Re: RADWP Addendum  
Area A: Sub-Parcel A3-1  
Tradepoint Atlantic  
Sparrows Point, MD 21219

On behalf of EnviroAnalytics Group, LLC (EAG), ARM Group Inc. (ARM) is pleased to submit the following Response and Development Work Plan (RADWP) Addendum to the Maryland Department of the Environment (MDE) and the United States Environmental Protection Agency (USEPA). This RADWP Addendum is being submitted to document several proposed changes to the development project on Sub-Parcel A3-1 (the Site) of the Tradepoint Atlantic property located in Sparrows Point, Maryland.

**Sub-Parcel A3-1 Addendum  
Proposed Work Overview**

**SHEET NUMBER**  
**C4.0**  
**SITE DETAILS**

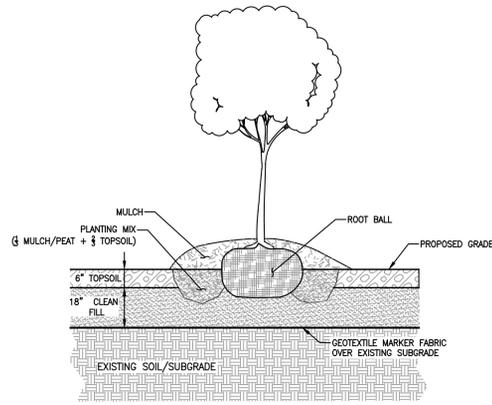
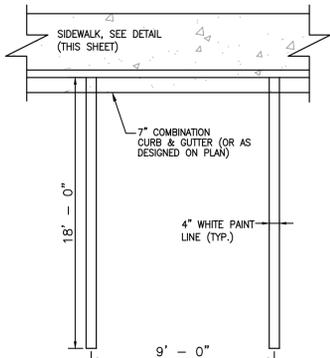
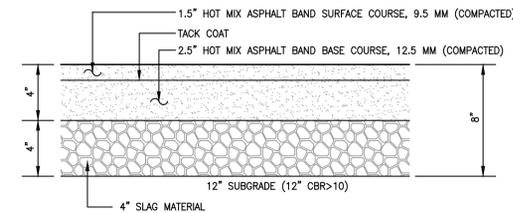
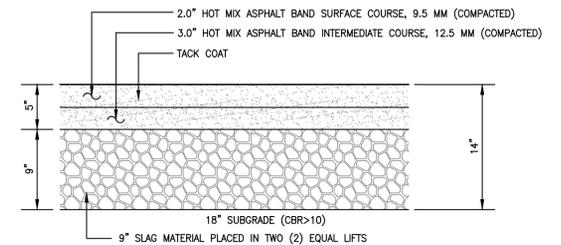
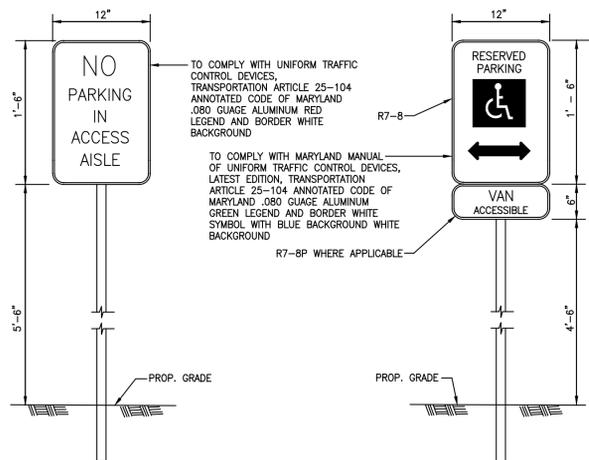
The proposed cap sections to be installed during this project are shown on *Sheet C4.0* within **Appendix A**. The proposed cap thicknesses meet the above requirements.
